CITY OF ELK GROVE

Access Compliance Assessment Report

June 2018

City of Elk Grove
June 2018
SSA Project # 17028

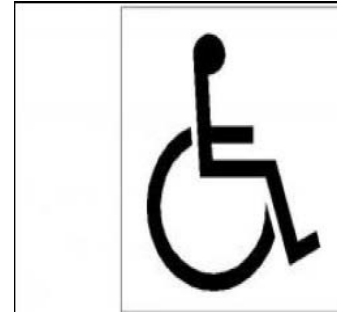
- *SSA As-Built Description:*
Accessible building entrance when not all are accessible not identified with a sign showing the International Symbol of Accessibility.
- *SSA Proposed Solution:*
Provide building entrance sign that shows international symbol at accessible entrance.

- *Original Problem Description:*
There is no signage with the International Symbol of Accessibility on the entrance door to the facility designating it as accessible.

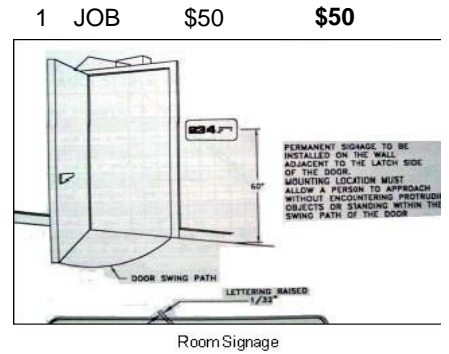
• *SSA Proposed Solution:*
Provide compliant signage including tactile characters and Grade II Braille on latch side of door located 60" on center from floor.

Main Entrance Door

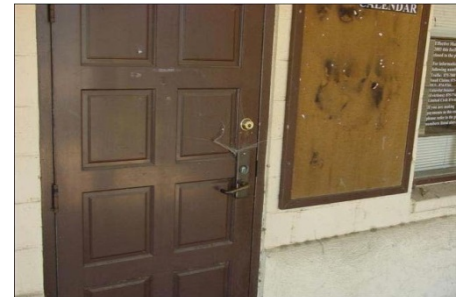
- *SSA As-Built Description:*
Accessible building entrance when not all are accessible not identified with a sign showing the International Symbol of Accessibility.
- *SSA Proposed Solution:*
Provide building entrance sign that shows international symbol at accessible entrance.

Rear Entrance Door

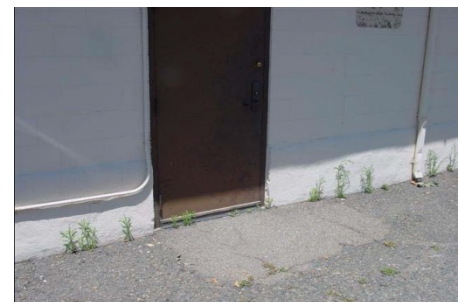
- *SSA As-Built Description:*
Landing less than 60" long (CA only: bottom landing less than 72").
- *SSA Proposed Solution:*
Modify ramp landing.

Reception Counter

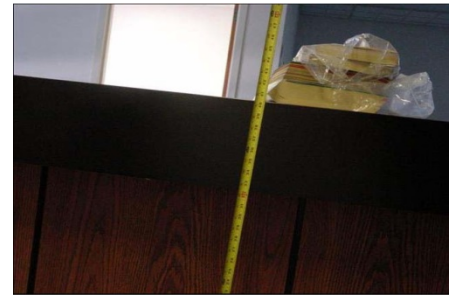
- *SSA As-Built Description:*
Signage to provide information regarding attendant services is missing.
- *SSA Proposed Solution:*
Provide sign stating "Attendant Service is Available".

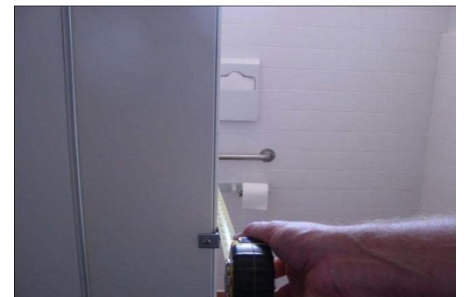
• *SSA As-Built Description:*
Dispensers for soap and towels, and waste receptacles more than 36" from floor to highest operating slot or control (CA only: More than 32" from floor to highest operating slot or control).

• *Original Problem Description:*
The seat cover dispenser in the restroom is mounted at a height greater than 40 inches.

• *SSA Proposed Solution:*
Provide new or modify specific restroom accessories.

• *Original Solution:*
Relocate the seat cover dispenser in the restroom so that the height is no greater than 40 inches above the finished floor (see CBC 1115B.9.2). Make certain that the location of the seat cover dispenser does not interfere with the use of a grab bar and provides sufficient clear floor space.

Raised Platform

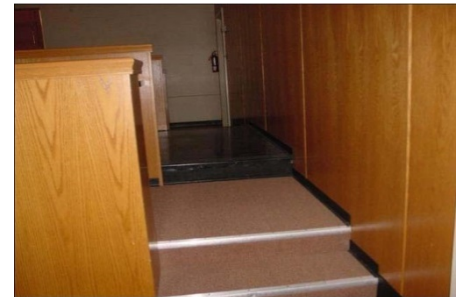
- *SSA As-Built Description:*
Ramp needed to provide disabled access at steps or change of level within building.
- *SSA Proposed Solution:*
Provide new ramp with handrails.

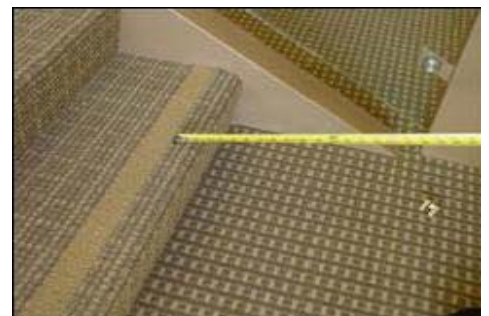
• *SSA As-Built Description:*
Stairs: There is no 2" wide contrasting color strip 1" from nosing on top & bottom treads (required in CA only).

• *Original Problem Description:*
There is detectable striping on the top and bottom treads of the interior stairway, but they are placed more than 1 inch from the front of the tread and do not provide enough contrast.

• *SSA Proposed Solution:*
Provide 2" min., 4" max. wide contrasting color strip 1" max. from nosing on top & bottom treads when altering area.

• *Original Solution:*
Affix detectable contrasting striping to the top and bottom treads of the stairway that clearly contrasts in color from the tread and is at least 2 inches in width placed no more than 1 inch from the tread nose or landing.

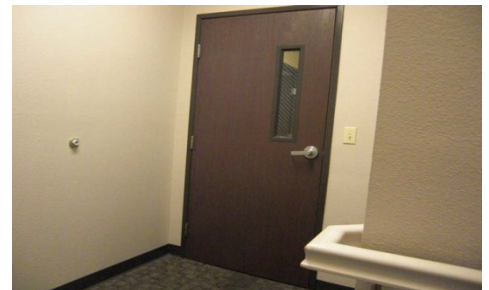
- *Original Problem Description:*
In the enclosed stairways there is no tactile stair level identification sign located at each floor level landing.

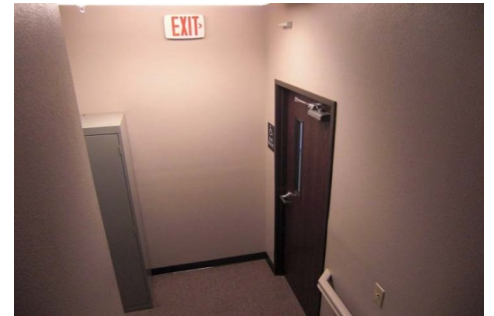
- *Original Problem Description:*
At exit discharge level, there is no sign including a raised five pointed star located to the left of the identifying floor level

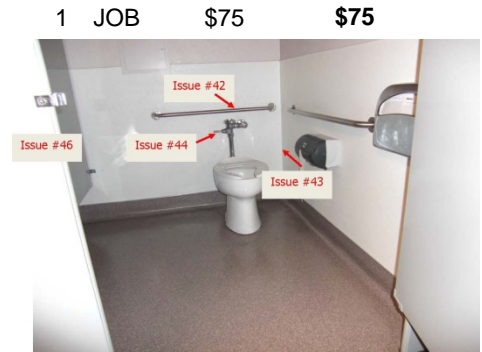
- *SSA As-Built Description:*
Toilet paper dispenser less than 15" (CA: 19") or more than 48" above floor or not within 7" to 9" from front of water closet (Note: CA pre-2010 is allowed within 12" from front of water closet).
- *SSA Proposed Solution:*
Relocate or provide new toilet paper dispenser.

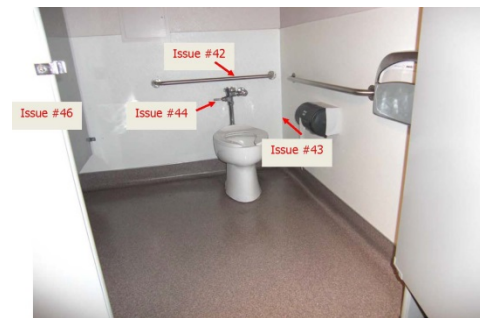
- *SSA As-Built Description:*
Flush Control: Operating handle requires more than 5 lbs force to operate.
- *SSA Proposed Solution:*
Replace flush control with properly mounted accessible type, or install sensor flush.

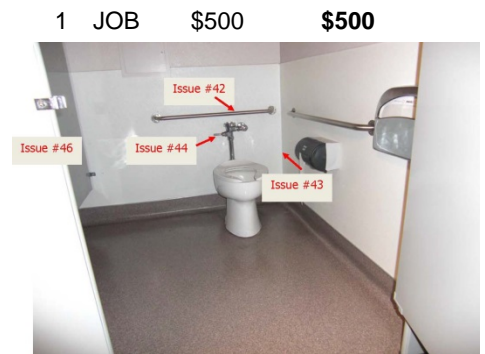
• *Original Problem Description:*
 The stile is 8" and should be no more than 4" maximum on this end opening door accessible toilet compartment. Further, the 18" stall front on the right side is on the wrong side of the door based on the position of the toilet.

• *Original Solution:*
 Reconfigure the front stall wall so that the door is located in front of the space on the wide side of the toilet and not in front of the toilet and the stile is no more than 4" maximum. CBC 1115B.3.1 4.3
